16 October 2019

Rebidding and Technical Parameters Guideline – Amendments for Five Minute Settlement 2019

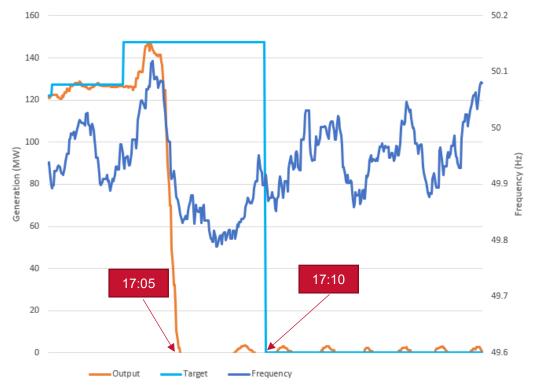
The example below shows a generator that reduced output to zero in response to negative prices during the dispatch interval ending 17:05 hours without a zero MW dispatch instruction for that interval. The actions of this generator resulted in a noticeable dip in frequency, although (in this instance) the frequency did not move outside of the frequency operating standard.

In this example, the early rapid reduction in output without an instruction was clearly unrelated to unforeseen technical or available energy limitations (although such factors might be relevant
